**PLANS AND DOCUMENTS  
referred to in the PDA  
DEVELOPMENT APPROVAL**

**Approval no:** DEV2024/1569

**RE: AURA PRECINCT 14 – PROPOSED CHILDCARE CENTRE  
RESPONSE TO FURTHER ISSUES**

Carparking

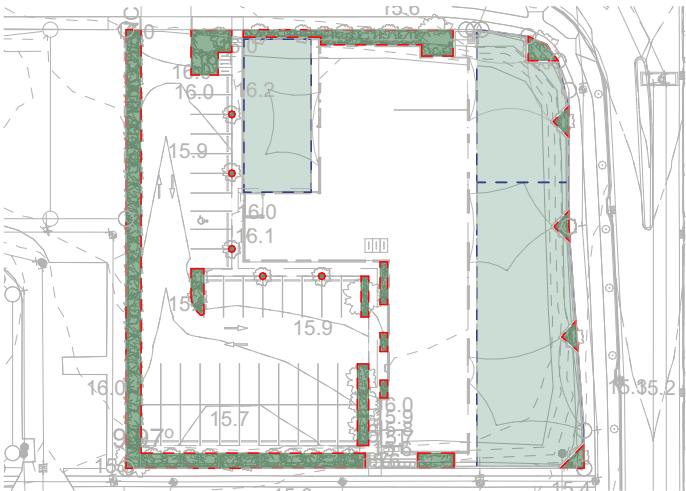
*“The proposed reduction in on-site car parking spaces from 44 to 37 is not supported, as it is considered too high of a reduction. The site is a new, purpose-designated, and unconstrained location, and the parking requirements outlined in the Plan of Development are expected to be met as closely as possible as reliance on on-street parking is not acceptable due to the anticipated high demand from residential and educational uses.*

*A reduction of up to 10 percent will be considered, requiring a minimum of 40 spaces to be provided on-site. The proposal must be redesigned to meet this requirement.”*

The proposed development layout has been revised to provide one additional car parking space, for a total of 38 spaces. This represents a surplus of five spaces compared to the expected demand (ie 33 spaces), based on the above parking demand survey data. As shown in Table 1, even when considering an occasional case where the proposed development operates at capacity, there would still be surplus of three parking spaces compared to the forecast demand (ie 35 spaces). Therefore, the proposed parking provision is considered adequate.

CARPARKING	
NUMBER OF STANDARD CARPARKS	26
NUMBER OF ACCESSIBLE CARPARKS	1
NUMBER OF STAFF CARPARKS	11
TOTAL	38
